Comment on Representation Relating to Draft Plan

**Comment on the Representations to
Draft Wan Chai Outline Zoning Plan No. S/H5/28**

Lee Theatre Realty Limited
Representation on the Draft Wan Chai Outline Zoning Plan No. S/H5/28
Relating to Lee Theatre Plaza, 99 Percival Street, Causeway Bay

**Representation in relation to the
Amendments to the Draft Wan Chai Outline
Zoning Plan Number S/H5/28**

Figure 6 : 200mPD SBDG Compliant Scheme

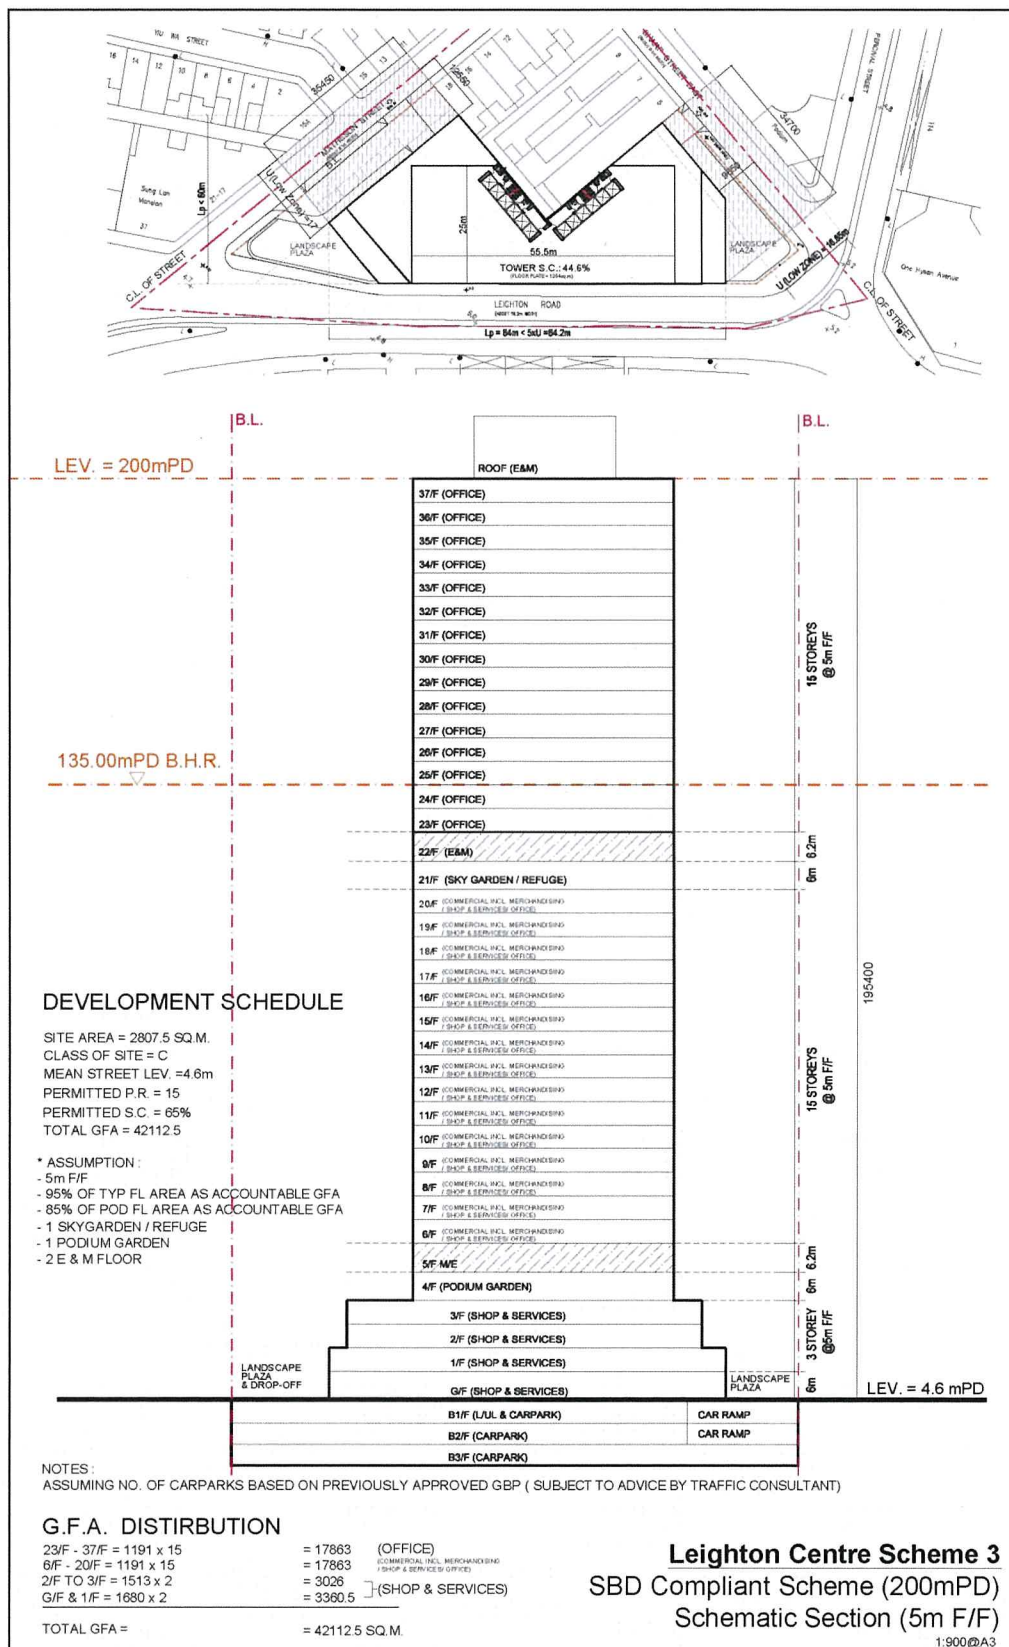
- 10.5 This scheme is the win-win option for the Representor, the TPB and the general public. The 200mPD scheme (see **Figure 6** is simply indicative, however, as detail design proceeded a scheme which is SBDG compliant, added to the functionality of the public realm in the area and contributes to place making in Causeway Bay would be developed. The 200mPD BHR would permit a building to be built which has better placed voluntary setbacks, such as Lee Garden One (see other examples in **Figure 7**) reducing the pressure on Matheson Street and Sharp Street East for both pedestrians and vehicles. There would be a redesigned run-in and run-out which would help with traffic issues and an on-site drop-off

area (see examples in **Figure 8**) which should help reduce congestion on Matheson Street.
